**Data Summary and Evaluation Report**  
**For Investigation Of**  
**High Priority Sites Potentially Contaminated With Lead**

**Responses to Review Comments on: Data Summary and Evaluation Report  
for Investigation of High Priority Sites Potentially Contaminated With Lead  
Scott Marquess, Environmental Protection Agency, Region VII (913) 551-7131**

<b>Responses to Review Comments on: Data Summary and Evaluation Report for Investigation of High Priority Sites Potentially Contaminated With Lead</b> <b>Cpt. Kathy Krantz, CEMRK-ED-GE, (816) 426-7885</b>	
Comment	Response
<p>1. Section 1.1, Page 1-1. "...in areas accessible to the general public (especially children)" should be enclosed by commas.</p> <p>The word "former" is used too many times in the second area description. Delete former from the "former pistol range."</p> <p>For the schools, what is meant by "near range areas?"</p>	<p>Concur. The text will be amended as indicated. "Near range areas" is the description of the original location of the fill materials used at the schools. When the schools were built, fill soils were taken from the areas near the firing ranges and placed in the school yard. The fill was taken from ar

PLATE 1 - CAMP FORSYTH RANGES SOIL SAMPLING LOCATIONS

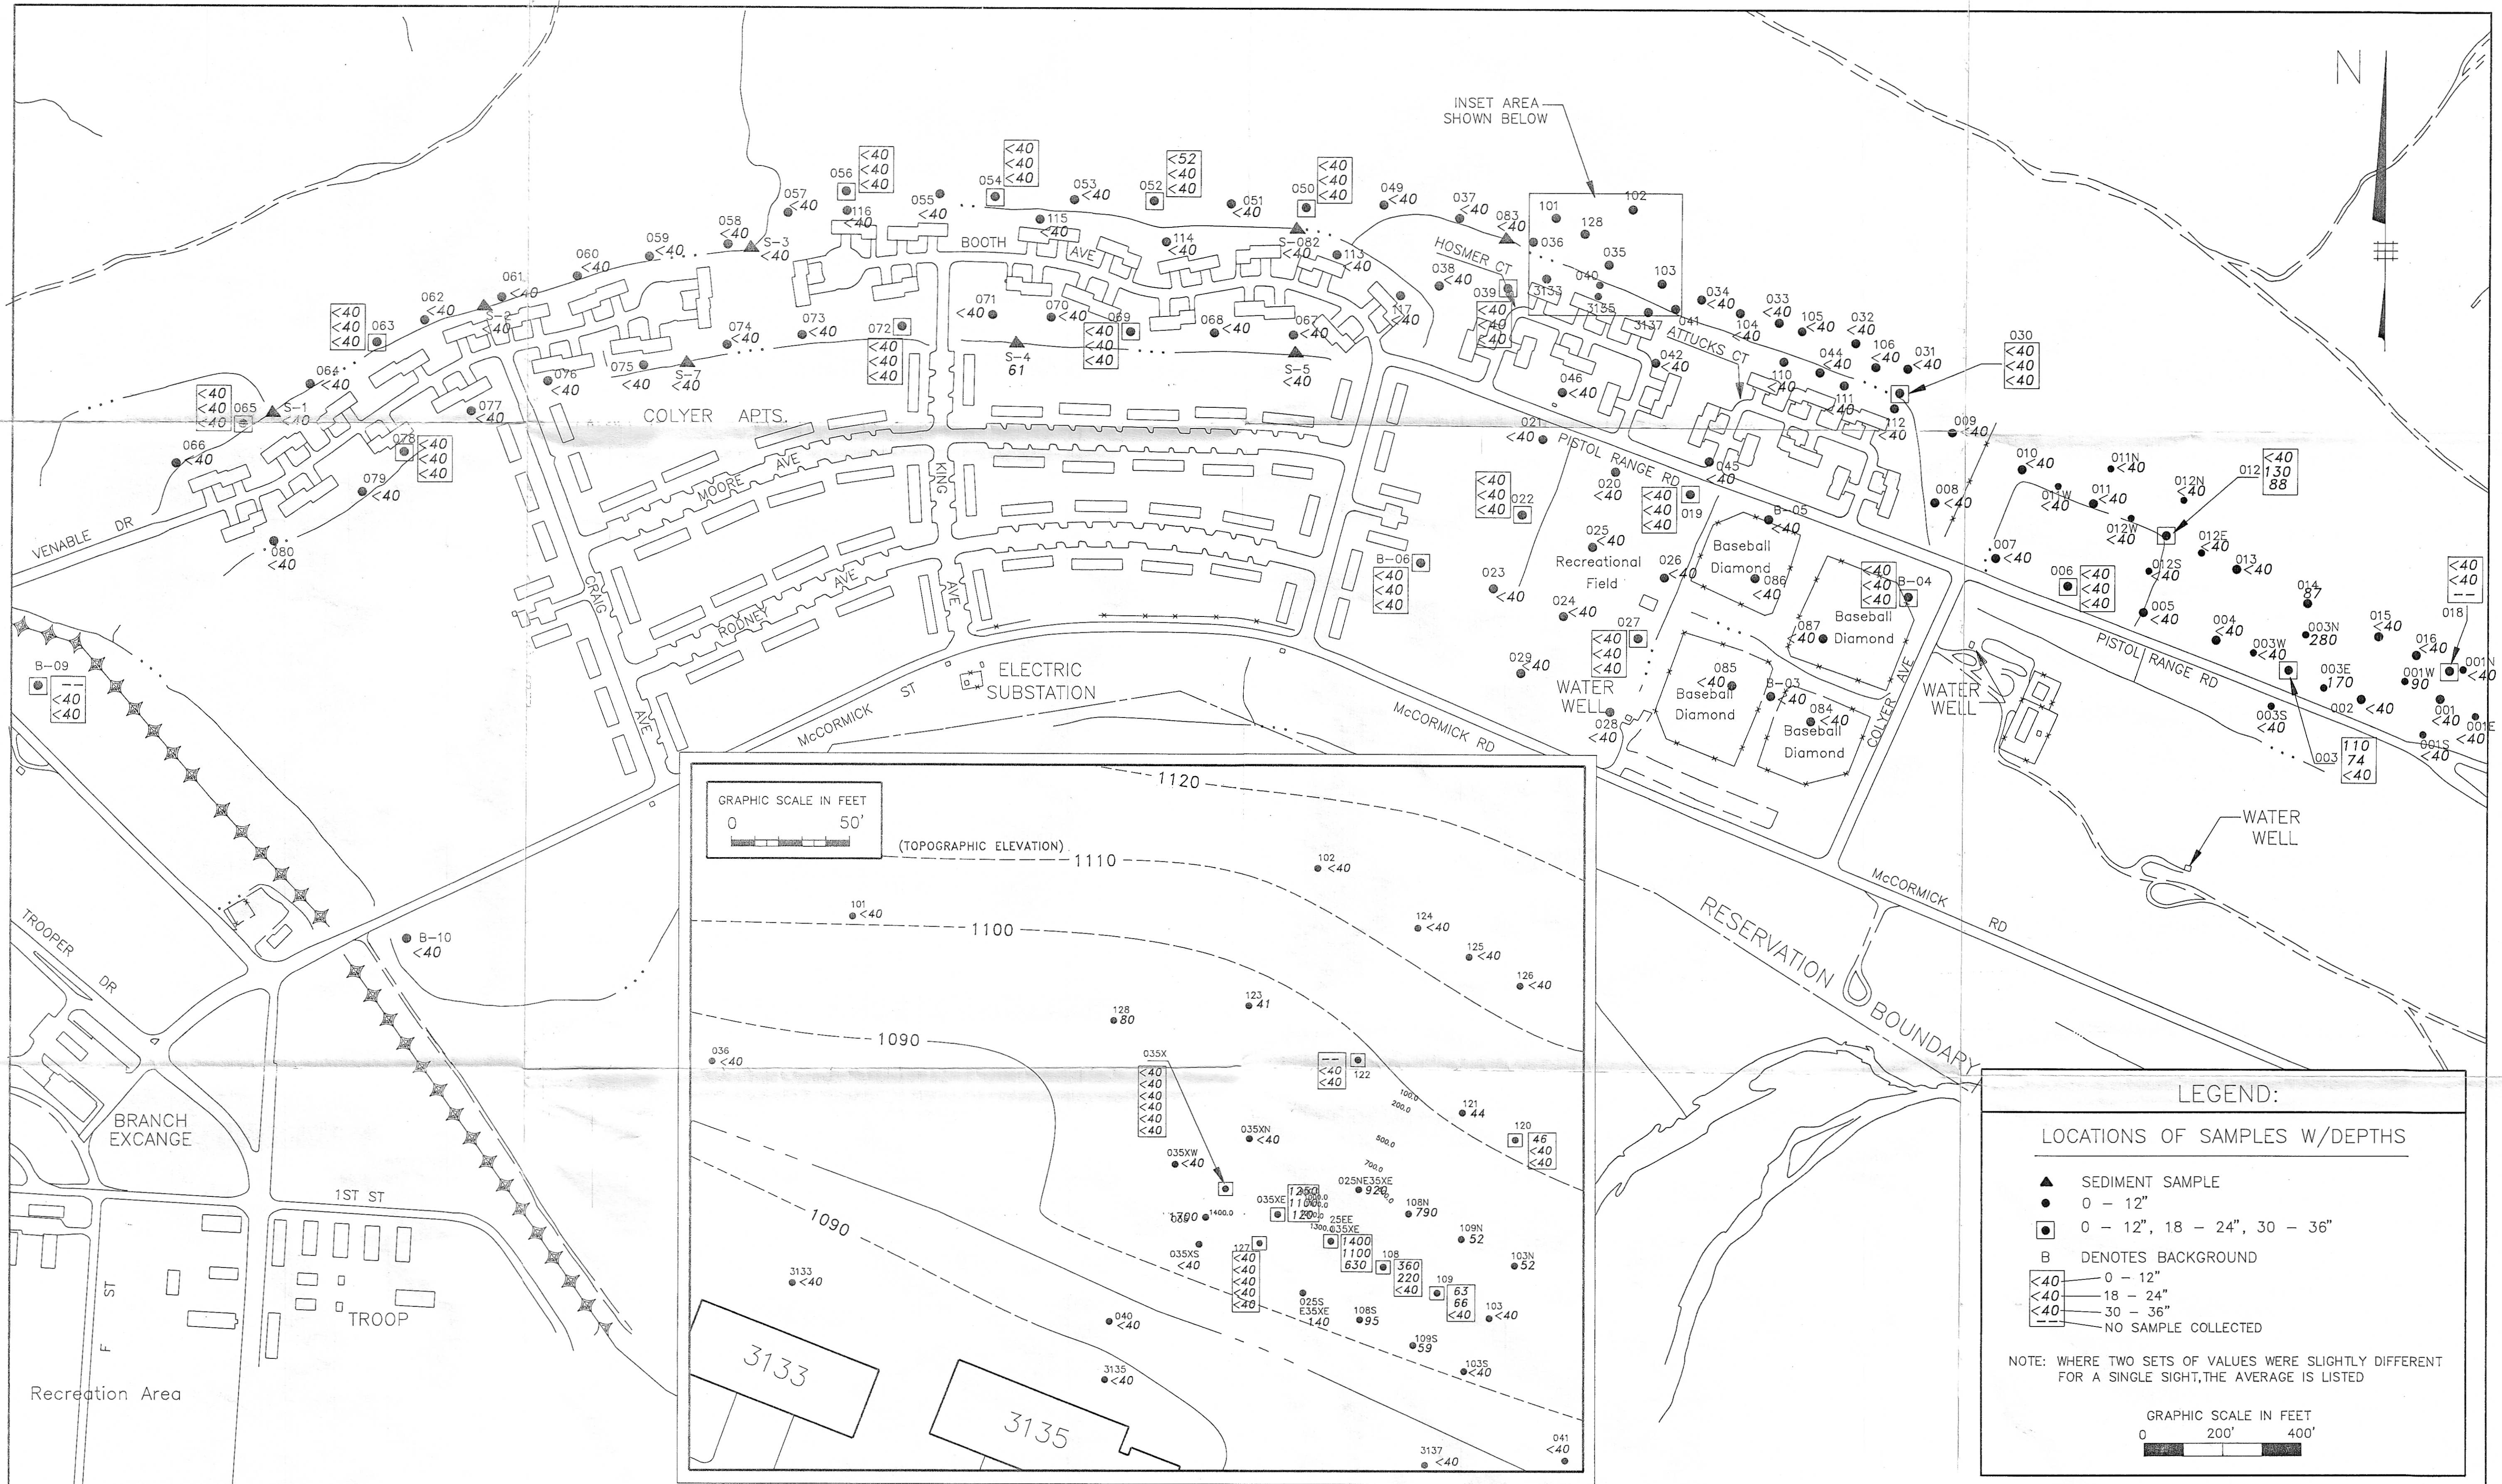
<p>22. References. The QAPP should also be referenced as this document provides the methods of analyses.</p>	<p>Concur.</p>
<p>23. Plate 2. Location 035xW is labeled 035xN.</p>	<p>Noted.</p>
<p>24. Plates 3. Location 06 has three depth values on the table.</p>	<p>Noted.</p>
